palisades preservation association

Case No.: ZA-20125-130-CDP
CEQA No: ENV-2012-131-MND
M&A Gabee, LP
16990-17000 Sunset Boulevard
Pacific Palisades, California
Supplemental Information

Figure 1. Map of Major H₂S-prone Areas in the Continental United States⁷

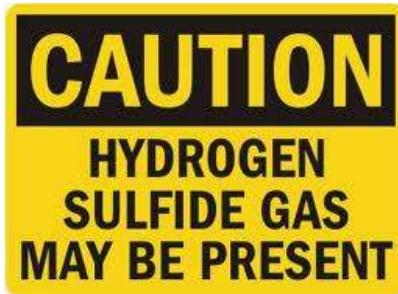
The next question is why did Mr. Salehipour go to such lengths to conceal the fact that there was H₂S gas on all the properties in the 16090-17030 Sunset area if as he states it is so easy to mitigate its impact? Any competent geologist knows that the Los Angeles Basin is one of the 14 areas in the United States that is designated as a major H₂S Prone area and that the Pacific Palisades lies within that Basin.

As noted in our letter of June 15, 2013, when the a West Los Angeles Area Planning Commissioner asked Mr. Salehipour if hydrogen sulfide was a hazardous gas, Mr. Salehipour replied that it was not. Either he was ignorant or he was deliberately misleading the Commission. It is unlikely that it was from ignorance for two reasons. First, ss tried to explain in the Addendum No. 1 to the Preliminary Geotechnical Report why some of the bore holes were so shallow that drilling had to be halted because of "dirty air", his description of H₂S. His drilling contractor would not stop drilling just because of an encounter with "dirty air" but because it was dangerous to continue drilling. When the smell of H₂S arises from a boring hole, it means that because H₂S is heavier than air and cannot rise, there was another gas present that was transporting the H₂S to the surface and that most likely is methane which is the most common carrier for H₂S. Methane is quite explosive and if the drill head set off a spark, it could blow the drill bucket right out of the hole or damage the drilling equipment.
